Work Order ID 152821

Item Name: AS350/AS355 Quick Release Heli-Utility-Basket™ Long, Heavy Duty Lid

DART SERVICE INSTRUCTION

TO AMEND INSTALLATION INSTRUCTIONS D350-607-3 Rev.D,
INSTALLATION INSTRUCTIONS D350-607-4 Rev. C AND
INSTRUCTIONS FOR CONTINUED AIRWORTHINESS ICA-D350-607 REV. 6
REF TCCA STC: SH94-14
REF FAA STC: SR00213NY
REF EASA STC: EASA.10016996
REF BRAZILIAN STC: 2007S03-03/-04/-05/-06

FIGURE 1: INSTALLATION OF D4775-041 FWD STRUT

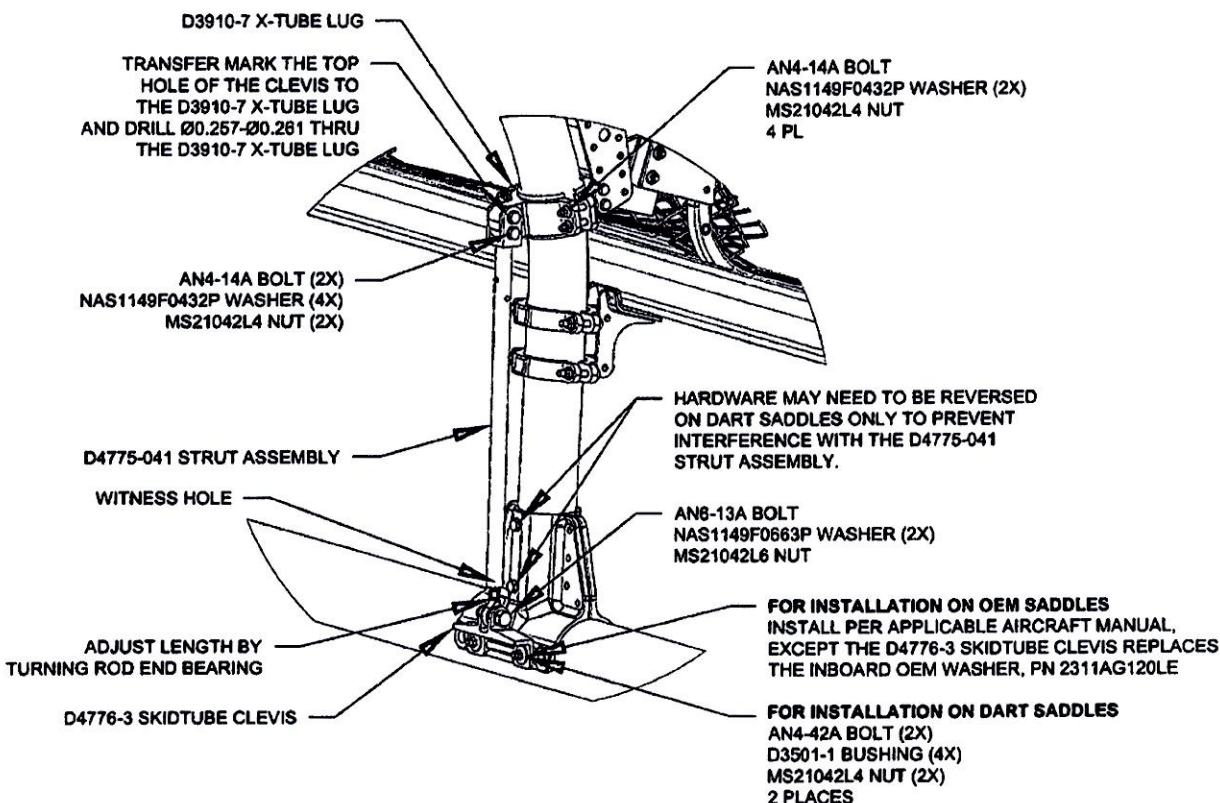
3.1 Substitute the Forward Lower D3910-5 X-Tube Lug with the D3910-7 X-Tube Lug as shown in Figure 1.

3.2 Install the forward D4775-041 Strut Assembly. Transfer mark from the upper hole on the clevis of the D4775-041 Strut Assembly to the D3910-7 X-tube Lug and drill thru the lug $\varnothing 0.257$ - $\varnothing 0.261$ as shown in Figure 1. Touch up chemical conversion coating per MIL-DTL-5541. Check the witness holes located at the bottom end of the D4775-041 Strut Assemblies to ensure that the thread from the rod end extends past the witness hole.
Torque MS21042L4/-4 nuts to 50-70 in-lbs (5.7-7.9 N-m). Torque MS21042L6/-6 nuts to 160-190 in-lbs (18.1-21.5 N-m).
